**STATE OF CALIFORNIA
AIR RESOURCES BOARD**

**Notice of Public Hearing to Consider)
Technical Status and Proposed Revisions)
to On-Board Diagnostic System)
Requirements for Passenger Cars,)
Light-Duty Trucks, and Medium-Duty)
Vehicles and Engines and Heavy-Duty)
Engines On-Board Diagnostic System)
Requirements, and to Consider)
Enforcement Provisions for Heavy-Duty)
Engines On-Board Diagnostic System)
Requirements.)**

**Hearing Date: May 28, 2009
Agenda Item 09-5-2**

**COMMENTS OF THE
ENGINE MANUFACTURERS ASSOCIATION**

The following is an illustration showing the impact of a 15% error

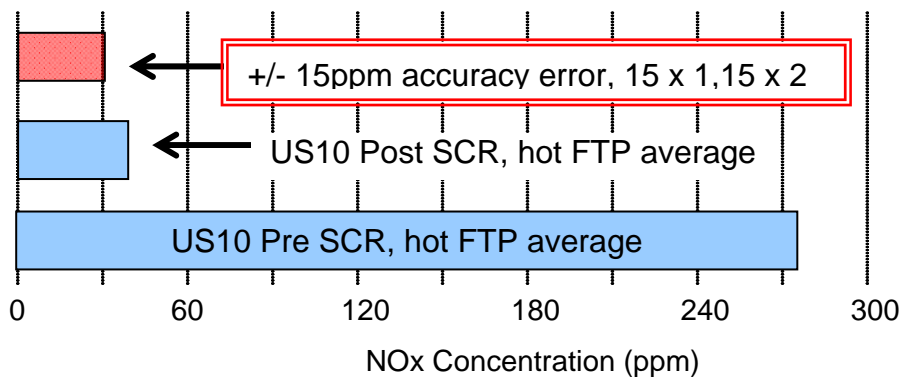
Furthermore, the discussion of feasibility in the ISOR fails to account for the combined tolerance error impact associated with the use of two NOx sensors on the same engine/aftertreatment system.

As the above illustrates, the accuracy error takes up most of the standard and does not allow for any separation between good and bad catalysts. Thus, monitoring to a threshold at 2x the standard is not technically feasible. ARB must revise the NOx catalyst and NOx sensor threshold upward to the standard +0.60 (4x std).
